Technical Service Information

CHRYSLER A404 HARD OUT OF PARK (NEW PARK ROD)

Figure 3

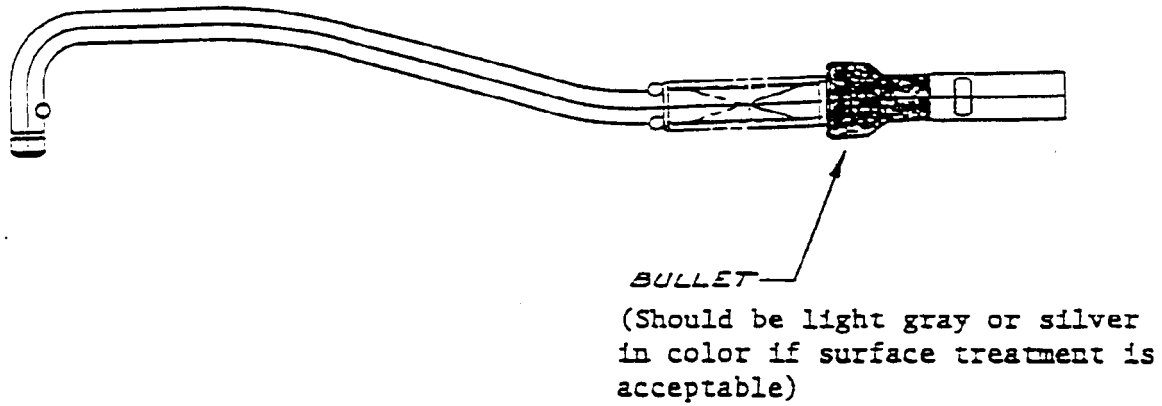
Inspect shift cable and linkage for proper routing and adjustment. If routing and adjustment are proper, the condition may be due to improper surface finish of the bullet end of the park sprag rod (Figure 3).

1. Remove the transaxle oil pan.
2. Remove the "E" clip retaining the park sprag rod to the valve body (Figure 4).
3. Remove the park sprag rod from the transaxle assembly and inspect the bullet end of the rod (Figure 1). If the bullet end surface is dark blue or black, replace the park rod assembly with PN 4207130 containing a bullet that is silver or light gray in color.
4. Reinstall "E" clip, install the transaxle oil pan, and refill with automatic transmission fluid.
NOTE: The manual shift lever (at the transmission) may have been bent if the vehicle operator has attempted to force a transmission with an improperly finished rod out of the park position. Therefore, after replacing the park sprag rod, check the shift lever and replace if lever is bent.
5. Check linkage adjustment and road test to verify operation.
